Product Change Notice (PCN)

PCN Number: PCN-0374303R-01

Product(s) Affected: CPE-267

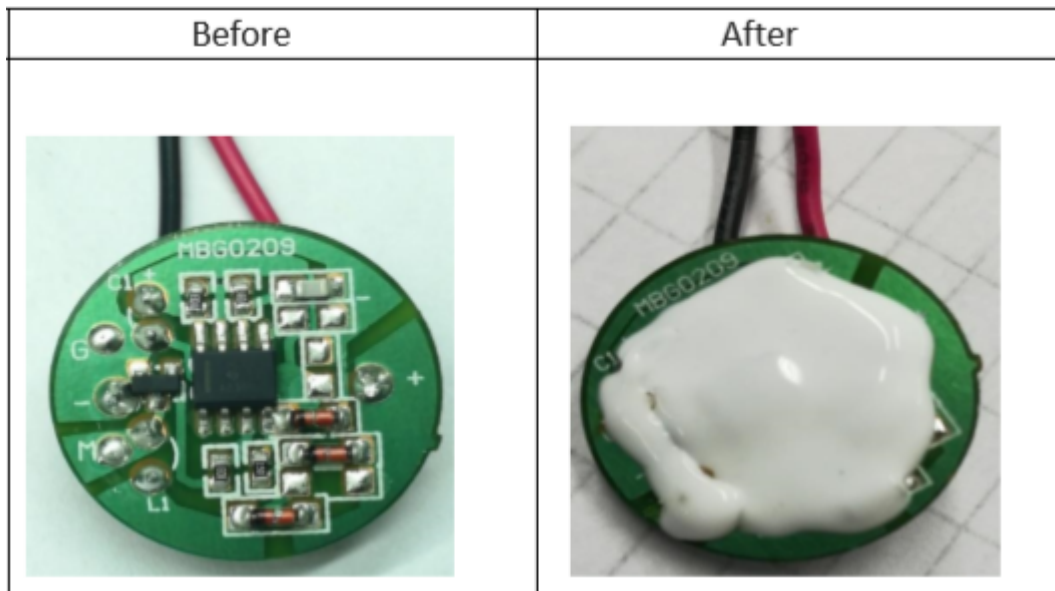
Description of Change: Addition of white protective glue to PCB, covering components and protecting solder joints.
